Item No. 1 - Addendum No. 2, Amendments to Drawings

Item No. 2 – Addendum No. 2, Amendments to Drawings, Item No. 7

Item No. 1 - Drawing A2.1

PROJECT NAME :
- PINEVIEW TERRACE LODGE NURSING HOME
-
- Prince Albert, SK

8 ROOF EXPANSION JOINT DETAIL
1 : 10

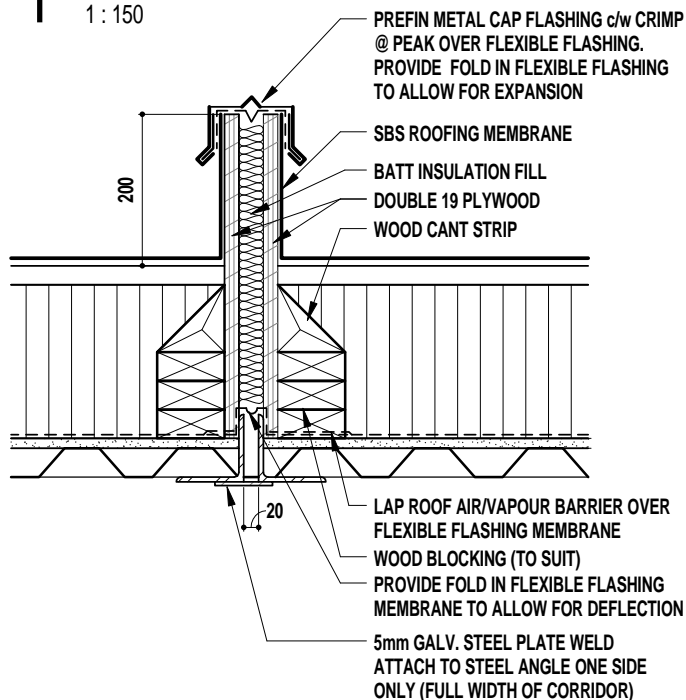
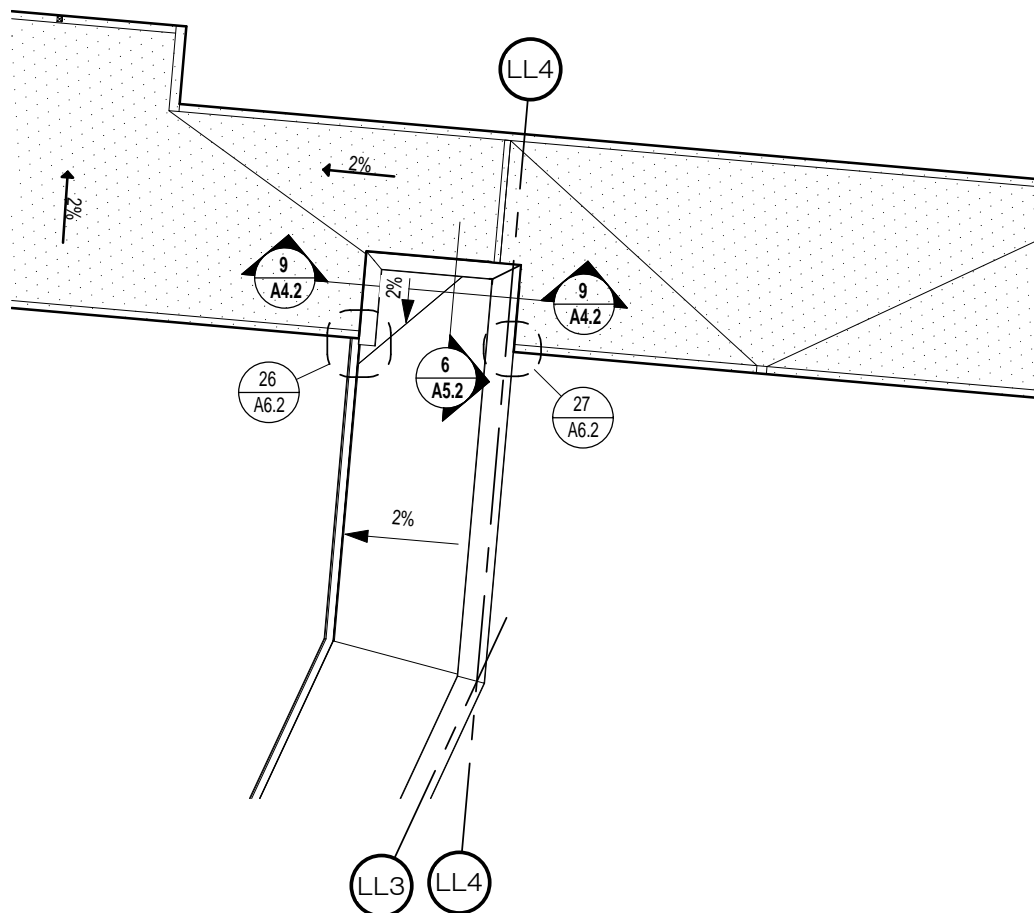
- .1 Add Roof Expansion Joint location and detail 8 as per attached drawing A2.5-R2
- .2 Plan details added at roof parapet. See attached drawing A2.5-R3 for locations.

A5.2-R6

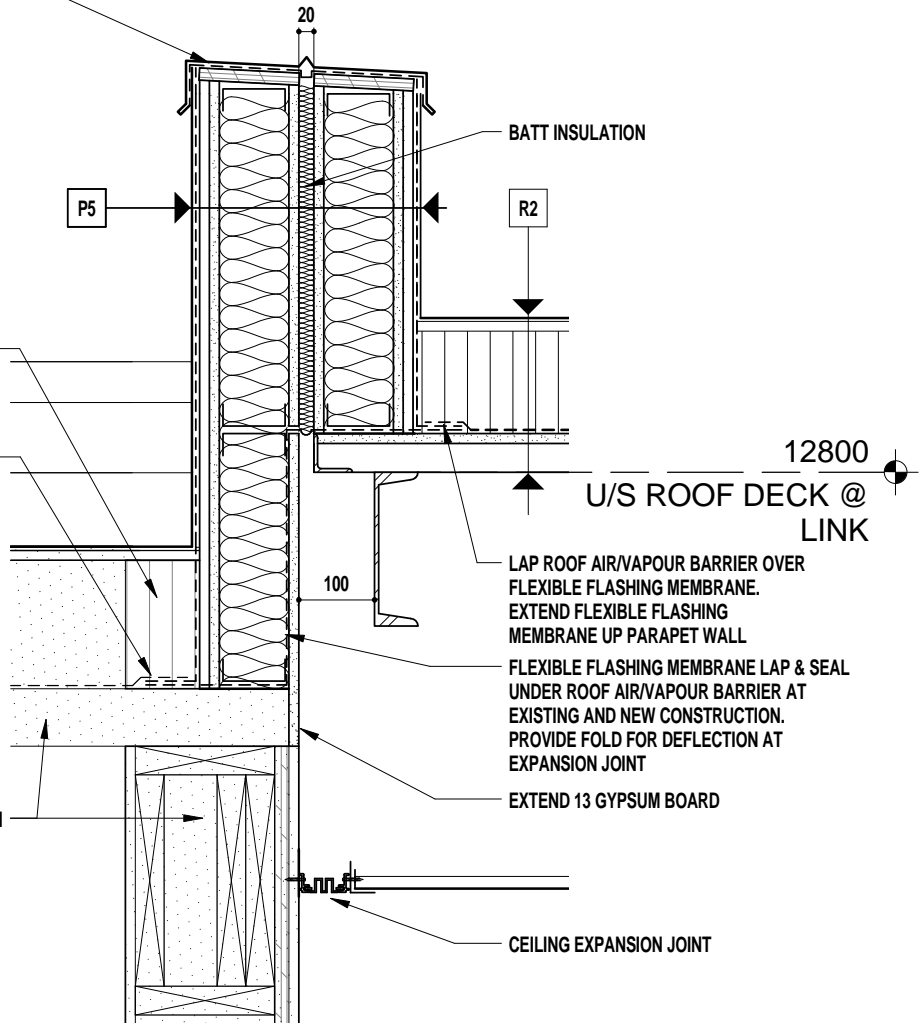
- .1 Drawing A5.2-R1
 - .1 Revise parapet detail 10 as per attached drawing A5.2-R5
- .2 Drawing A5.2-R2
 - .1 Revise parapet detail 11 as per attached drawing A5.2-R6.
- .3 Drawing A-5.2-R4
 - .1 Revise parapet detail 13 as per attached drawing A5.2-R7.

DWG. NO. :
A6.1-R2

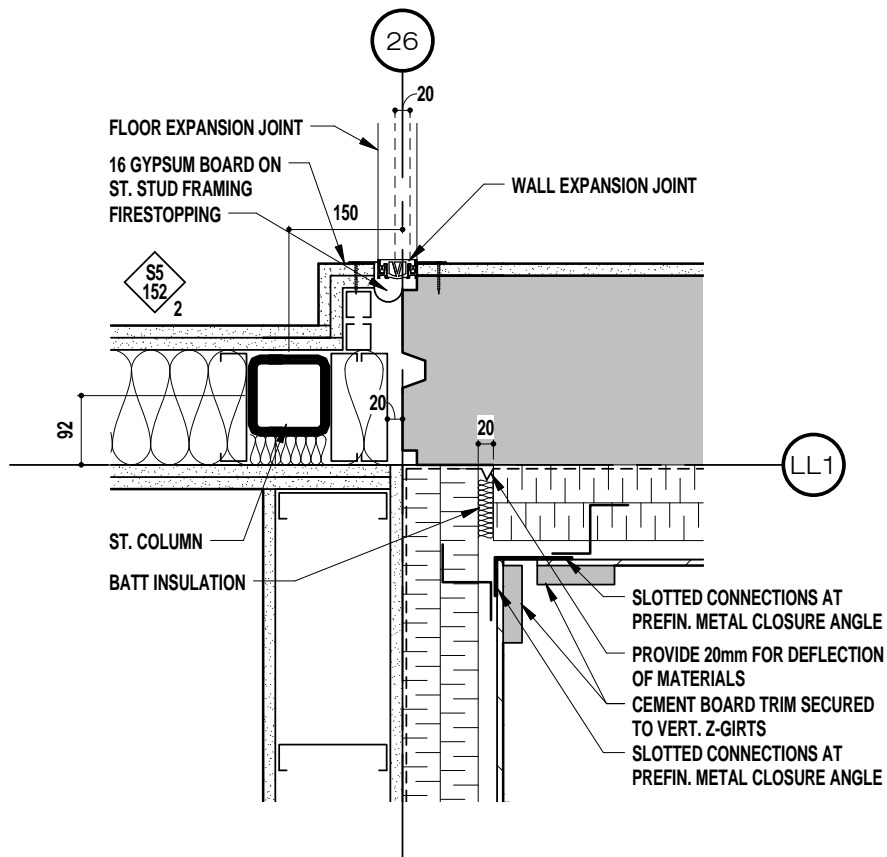
- .1 Add Floor expansion joint detail 22. Locate at Gridline 26 at both Basement and First floor. See attached drawing A6.1-R2

WALL EXPANSION JOINT DETAIL
1:10

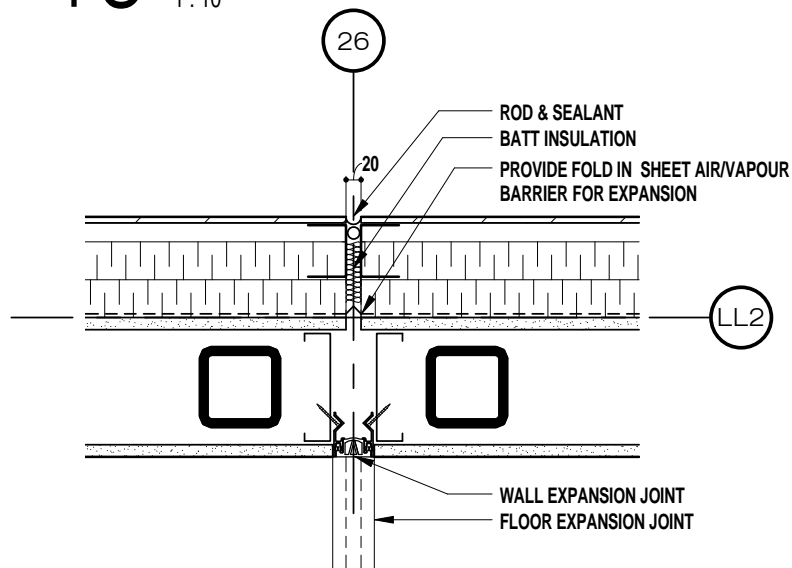
- .1 Revise Plan Detail 16 to include wall expansion joint. Wall expansion joint Detail 25 added at Grid LL2 & 26 . See attached drawing A6.2-R2
- .2 Revise Plan Detail 17 & 23 to include wall expansion joint. See attached drawing A6.2-R3
- .3 Plan details 26 & 27 added at parapet. See attached drawing A6.2-R4.

DWG. NO.:
S2.3.3-R2

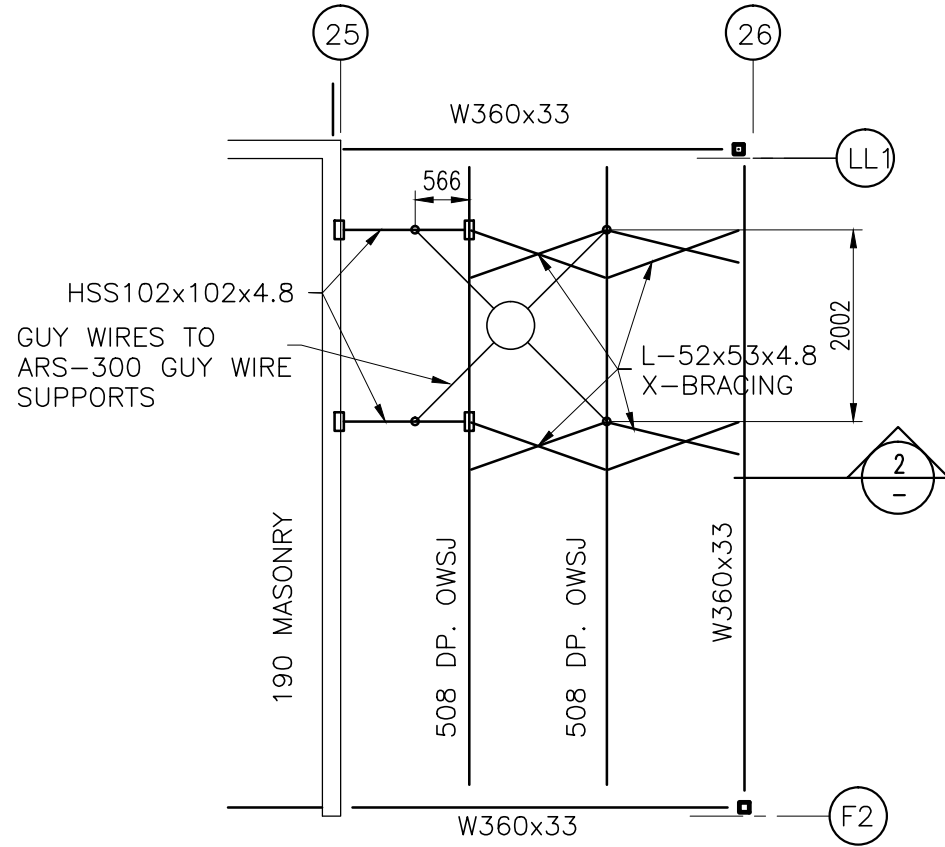
1. Refer to S2.3.3-R2 for new 4500 square structural slab to be located at entry to Kingsmere Villa bearing on top of new tunnel roof.
2. Detail 4/5 to be coordinated with detail 9/10/11 on A1.1 for connections of railing and handrail.

DATE : FEB. 7/12
 PROJ. NO. : 09,038
 DRAWN BY : J.B.
 DWG. NO. : S5.2-R1

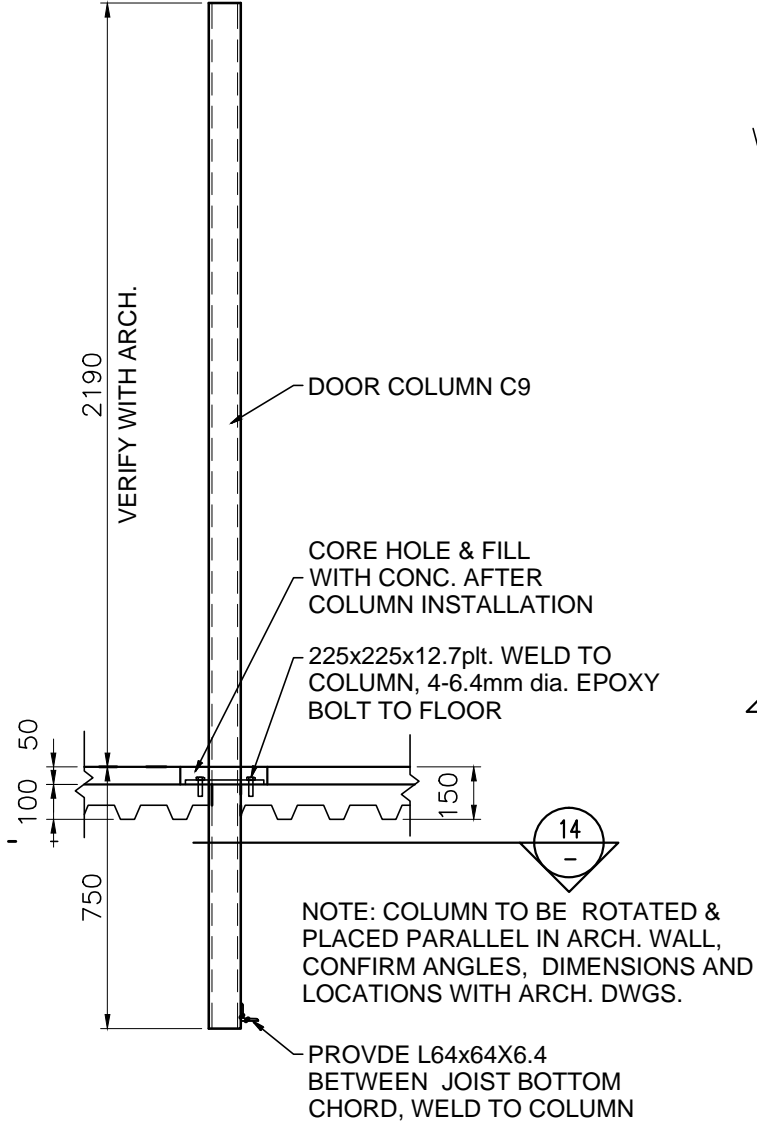
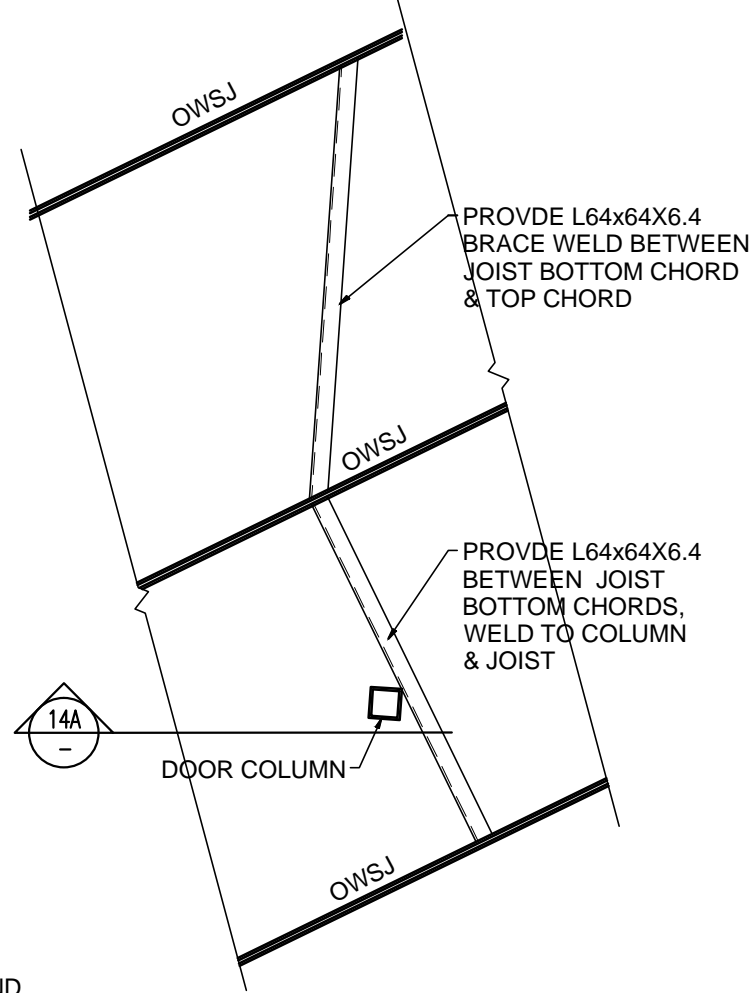
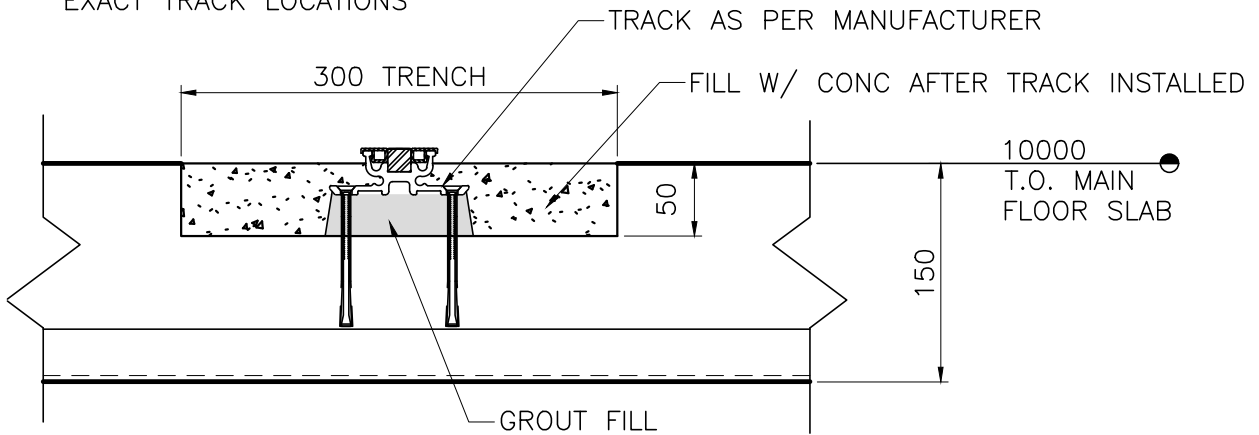
1. Detail 13, angle for openings to be attached to u/s of decking as per spec. Form u/s of angle to required depth by socket supplier.
2. Detail 14, refer to S5.2-R1 for additional braces & plates for columns.
3. Provide reinforced mounting for dock seals as per attached S5.2-R2
4. Reference to ADD # 2, drawing A5.2-R1. Supply 2-L102 x 102 x 4.8 angles and install to under side of W200 link beam as shown. Site weld to u/s of W200 with plug welds @ 375 o/c. Intall1 btm angle tight to u/s of existing wood deck & weld to upper angel with 4mm x 25mm fillet weld @ 375 o/c. Do not secure angle to wood deck.
5. Reference to ADD # 2, drawing S5.2-R2. Supply L102 x 102 x 4.8 angle and bolt to face of concrete wall, tight to u/s of existing wood deck. Use 12 x 127lg wedge anchors spaced @ 450 o/c. Do not secure angle to wood deck.

DWG. NO. :
S5.3-R3

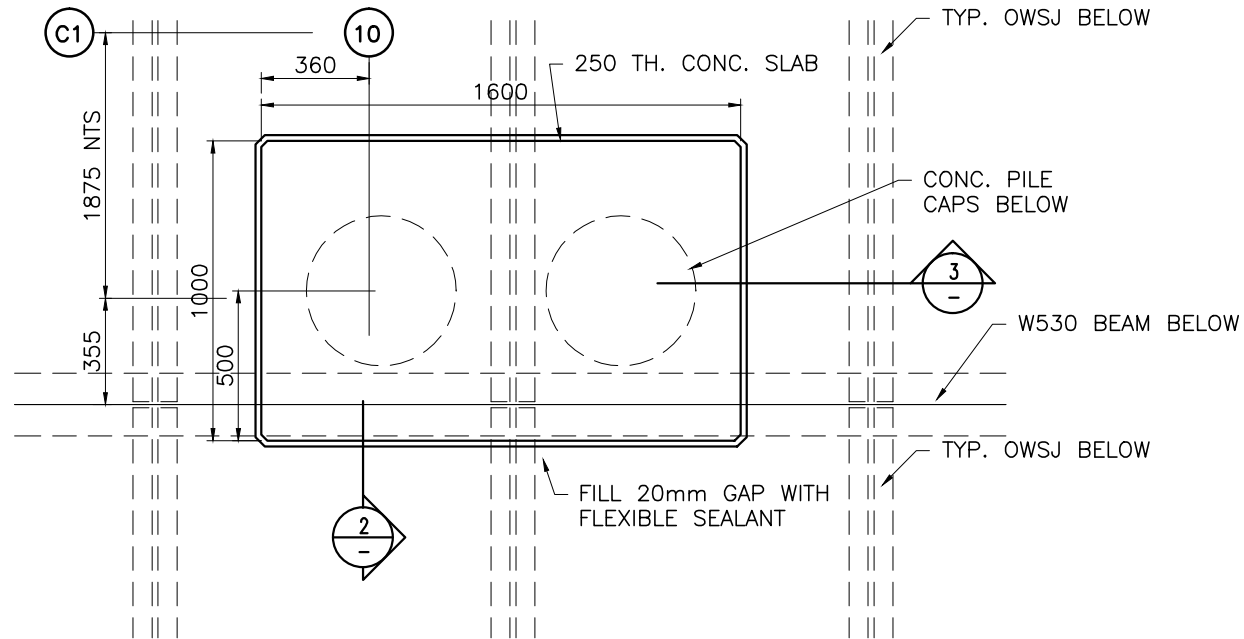
1. Detail 13, at centerline of beam.
2. Detail 14, joist seat 132 at centerline of beam.
3. Detail 20, column is 144 off grid 15 and 2800 off grid 9.
4. Provide lateral bracing for sliding door, headers 2 locations RM 143. (143B & 143C). Supply brace to roof system to match stud framing spacing. Design to provide lateral support at lead of sliding door. Refer to details 26/S5.3-R1 & 27/S5.3-R2.
5. At RM 142 sliding door 142C and 142B, provide HSS header at top of door. Frame onto steel studs as per detail S5.3-R3. Dimensions to be verified with Arch dwgs and door supplier.
